Product Change Notification – 2021/03

Product Line:	Slim Jacks	Part No:	NRJ*H*
Piece Part:	Housing and Contact	Part No:	-
Engineering Change Request:	2020-0348 2020-0349 2020-0350	Date:	04 Feb. 2021
Comments:	Material upgrade UL94 HB to UL94 V-0

Engineering Change Notice

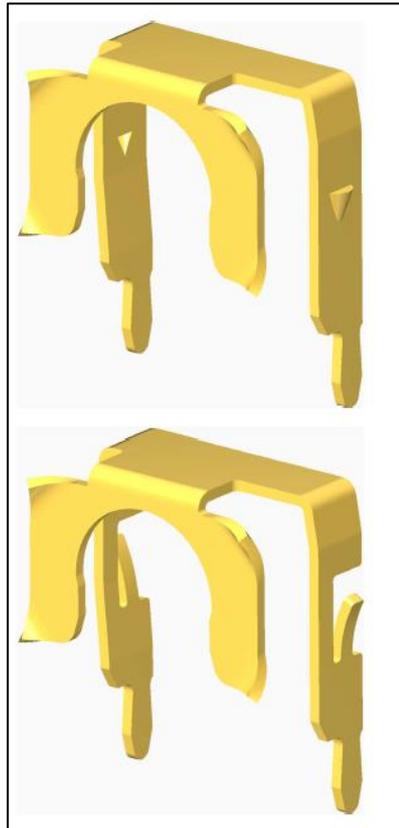
Due to the new IEC 62368-1 standard the Neutrik Stacking Jacks have been modified. To ensure the compliance according to this new standard, the material has been changed from UL94 HB to UL94 V-0 classification. Because of slight different material properties also the contacts were changed to ensure robustness and durability.
